LYNDHURST GARDENS

PLANTING PLAN LAYOUT  
GROUND FLOOR  
PLANTERS

PROJECT NO. 639/14	DRAWING NUMBER: PL403	REVISION: P02
-----------------------	--------------------------	------------------

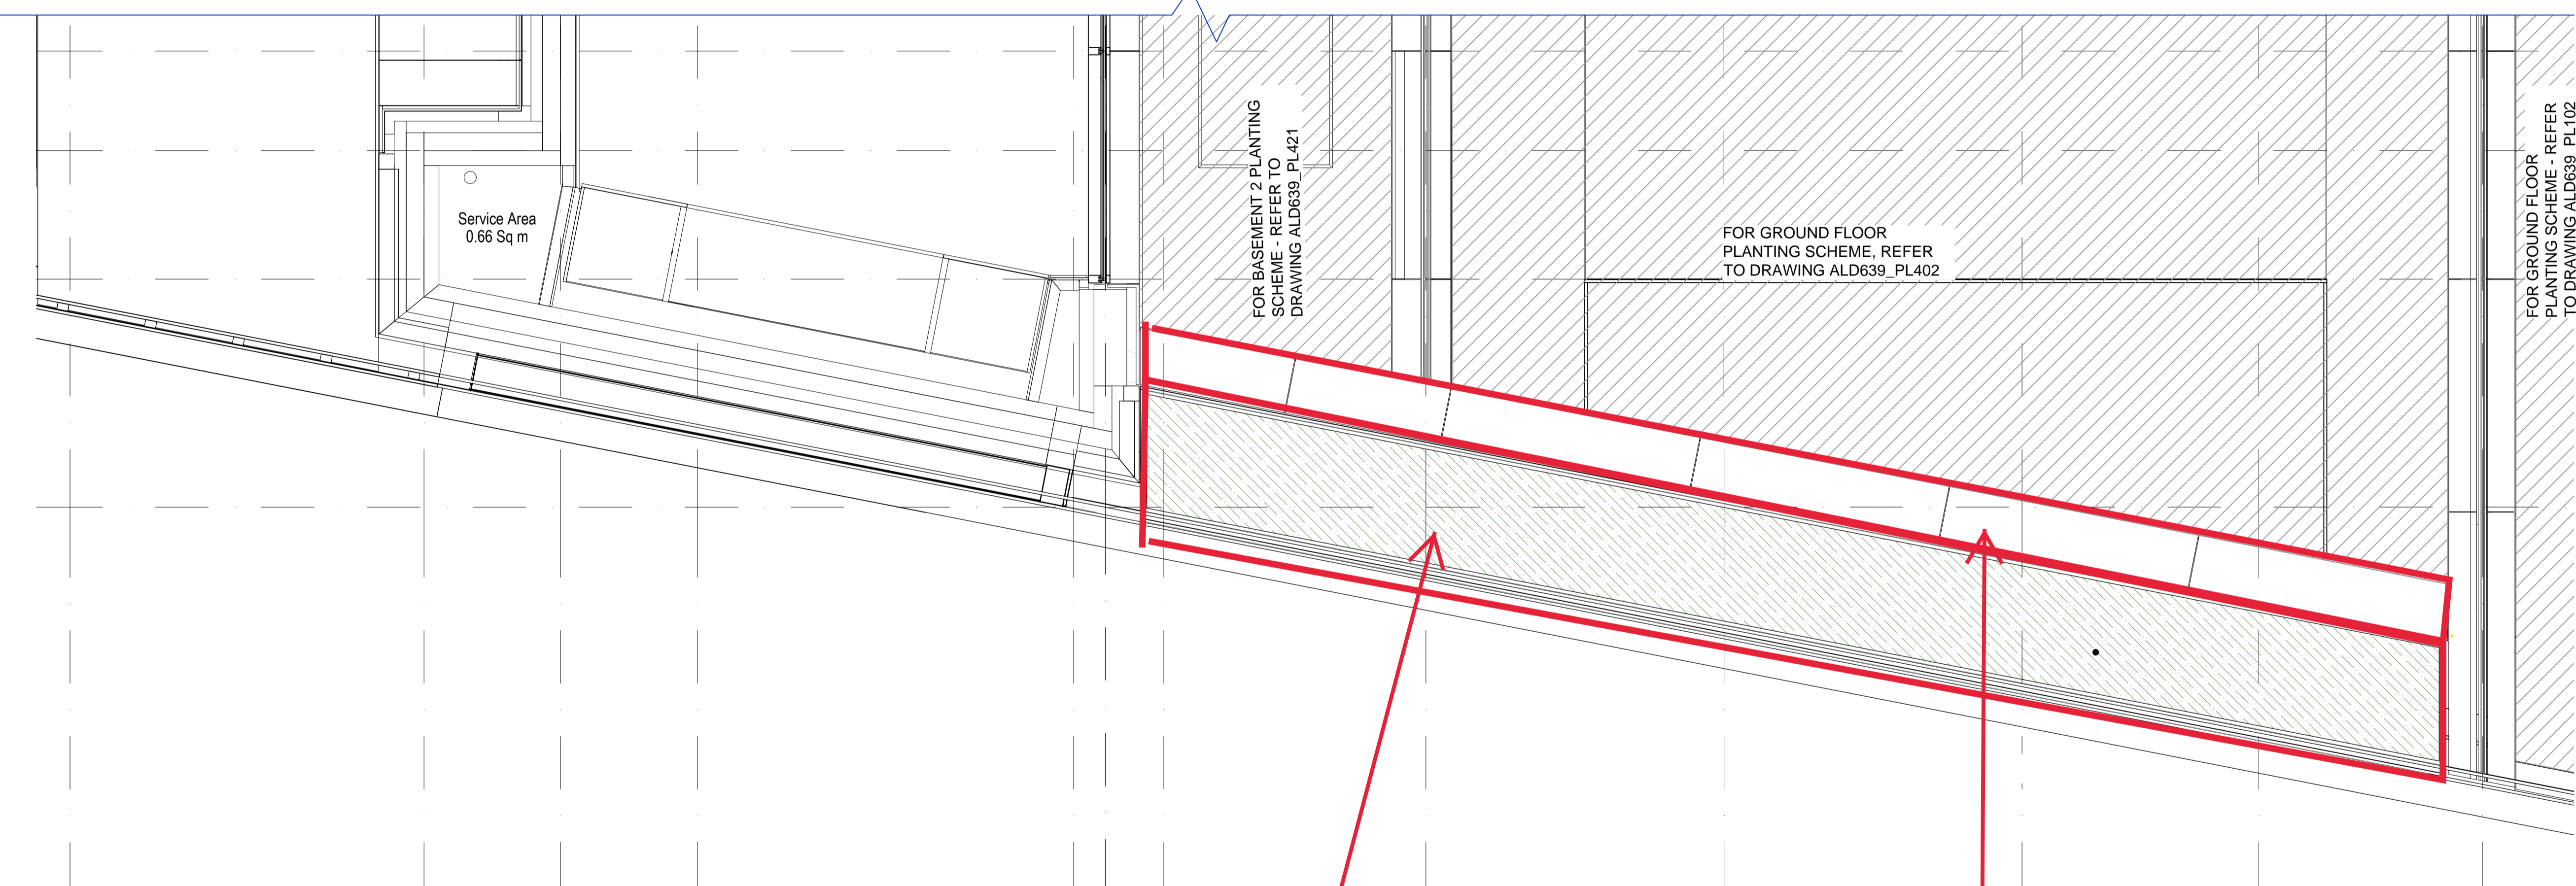
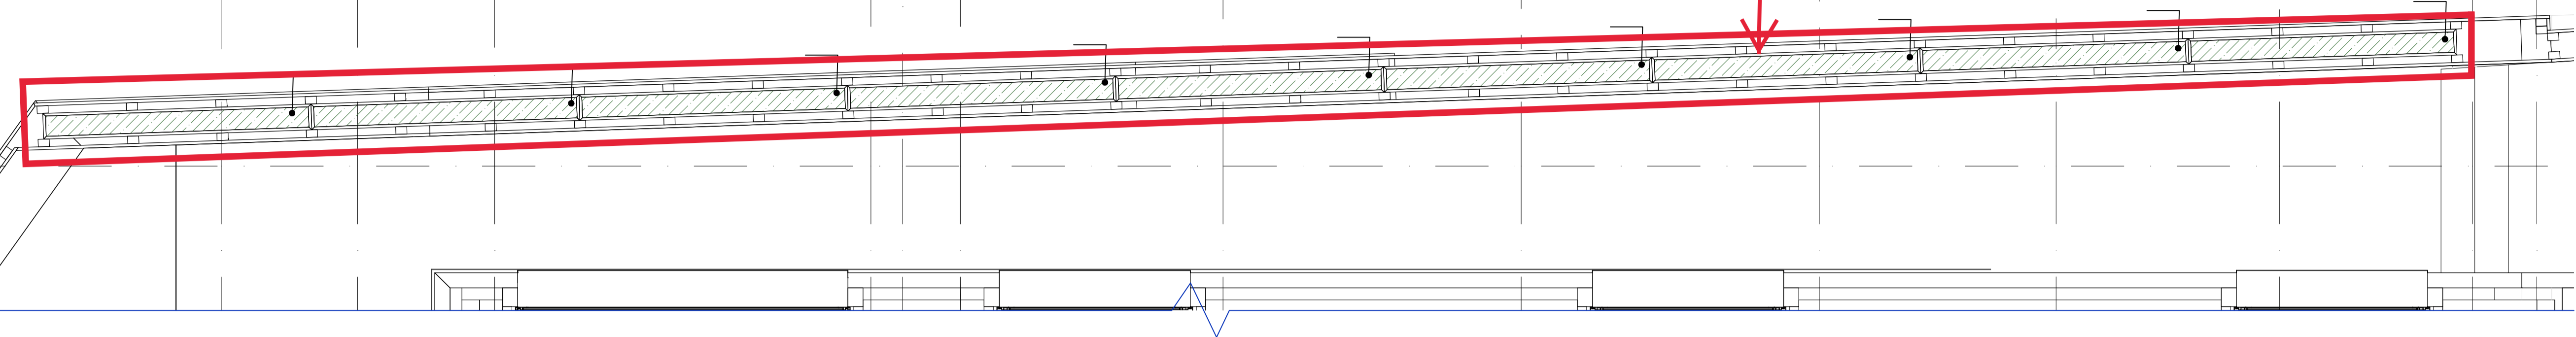
Planted trellis to be replaced with 410mm timber slatted trellis. Access issues removed the ability to effectively and safely incorporate the planted feature.

Planting to side boundary omitted and replaced with stone paving slabs to allow for access to maintain the existing boundary wall. See drawing number 3104 for hard landscaping details.

Line of glazing to be extended along the lightwell boundary to provide guarding safe working zone to allow for maintenance to the boundary. See drawing number 3104 for hard landscaping details.
